May 9, 2014
BW140044

Subject: Braidwood Unit 1 - Pressure and Temperature Limits Reports (PTLRs),
Revision 7
Braidwood Unit 2 - Pressure and Temperature Limits Reports (PTLRs),
Revision 6

**Braidwood Unit 1
Pressure and Temperature Limits Report (PTLR), Revision 7**

**Braidwood Unit 2
Pressure and Temperature Limits Report (PTLR), Revision 6**

Figure 2.1
Braidwood Unit 1 Reactor Coolant System Heatup Limitations (Heatup Rate of 100°F/hr)
Applicable for 32 EFPY (Without Margins for Instrumentation Errors)

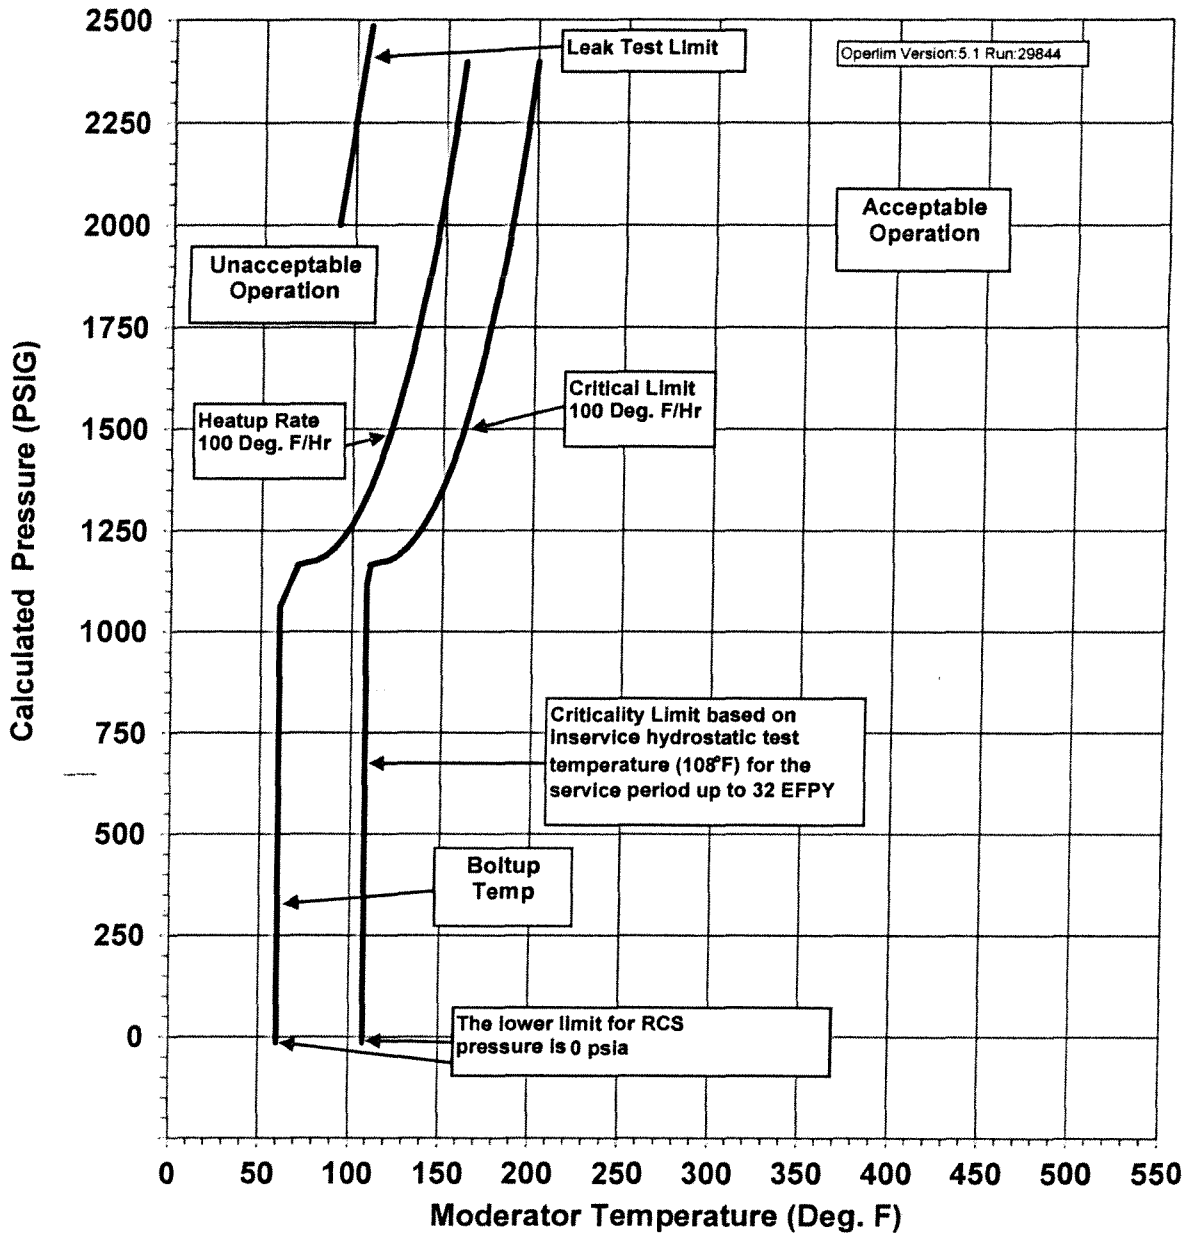
The lower limit for Reactor Coolant System (RCS) pressure associated with RCS heatup and RCS cooldown was extended from 0 psig to 0 psia to bound RCS pressure experienced during RCS vacuum fill operations and to maintain compliance with Technical Specification 3.4.3, "RCS Pressure and Temperature (P/T) Limits." The RCS heatup limitations (i.e., Figure 2.1 and Table 2.1a) and RCS cooldown limitations (i.e., Figure 2.2 and Table 2.1b) were revised accordingly.

Note 1: The Minimum acceptable pressure is 0 psia
